# TOWN OF DAVIE

## TOWN COUNCIL AGENDA REPORT

**TITLE OF AGENDA ITEM:** SP 4-6-03 Orange Park Office Building

1. Site Plan
2. Future Land Use Map
3. Zoning and Aerial Map

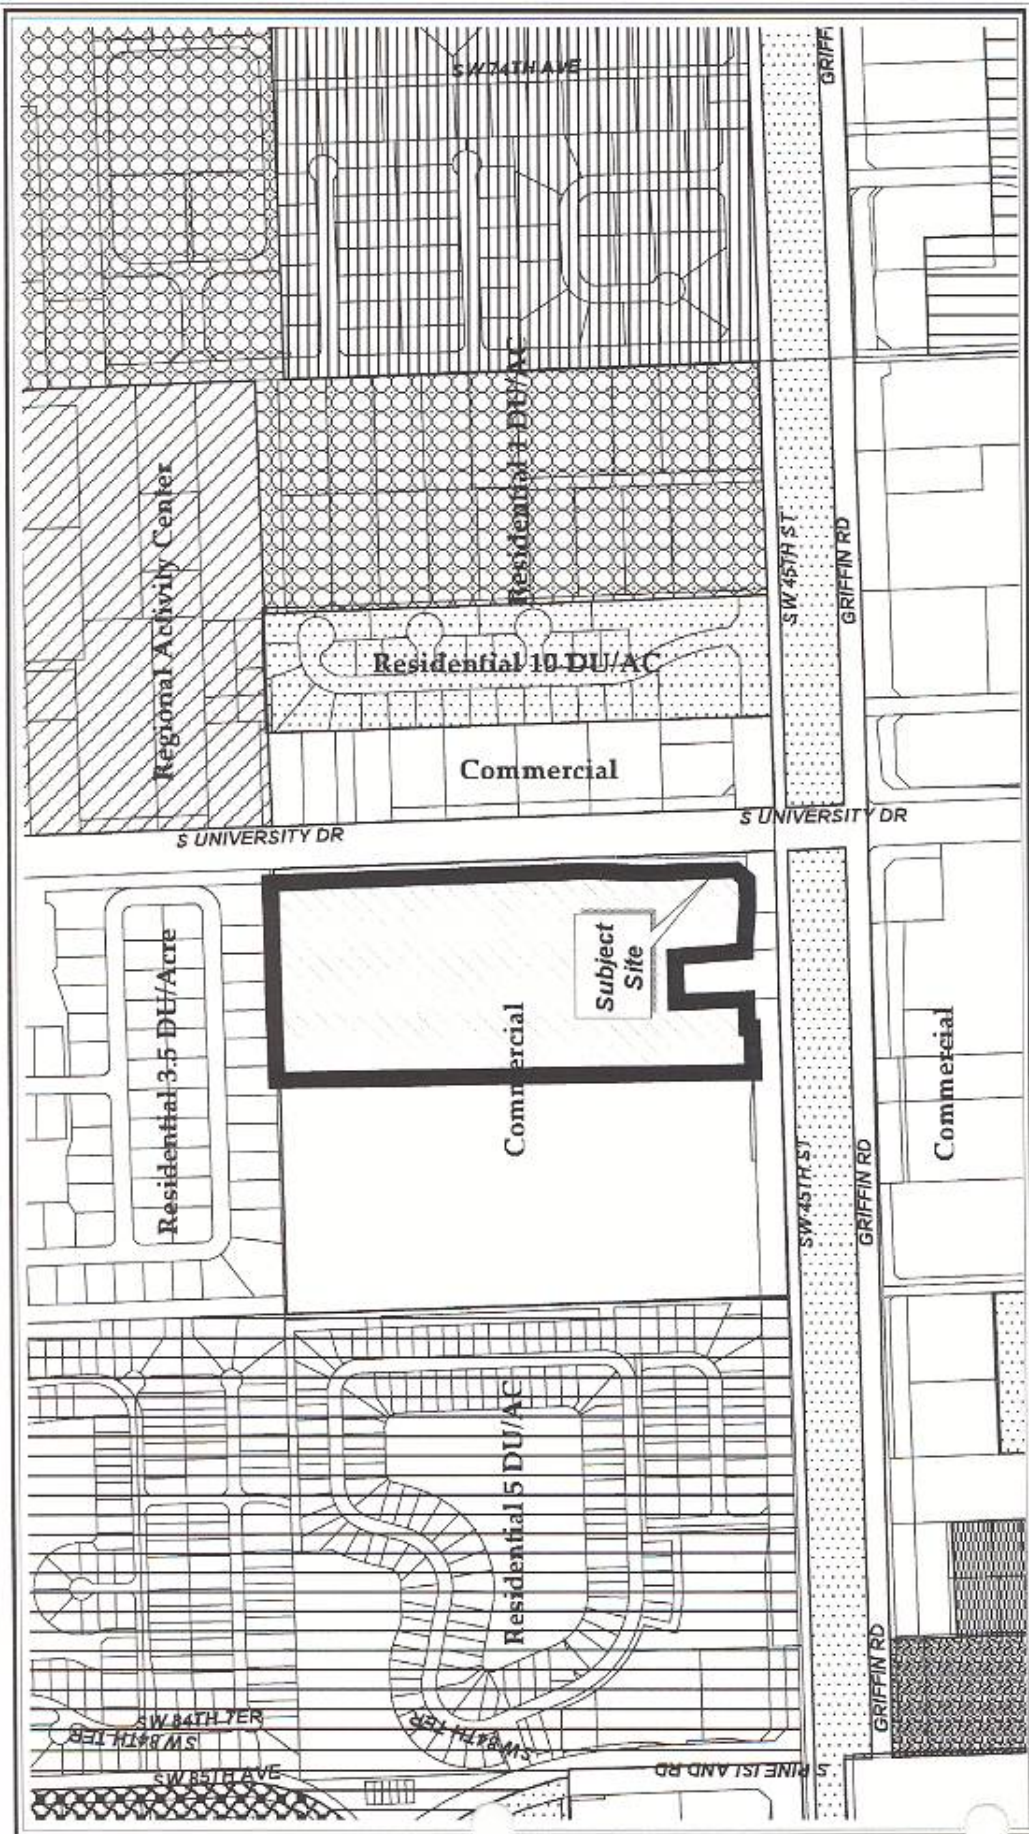
1. That the circulation plan shown on the architectural and engineering both match;
2. That a two-way drive be provided around the parking area;
3. That the existing fence be fixed or removed if it belongs to the applicant;
4. And if keeping any portion of the existing house, it should be shown on the site plan and floor plan.

Vice-Chair Evans made a motion, seconded by Mr. Breslau, to approve based on the planning report; that the circulation plan shown on the architectural and engineering both match; that a two-way drive be provided around the parking area; that the existing fence be fixed or removed if it belongs to the applicant; and if keeping any portion of the existing house, it should be shown on the site plan and floor plan. Motion carried 5-0.

***Note:** The applicant has revised the plans to reflect the Site Plan Committee recommendations.*
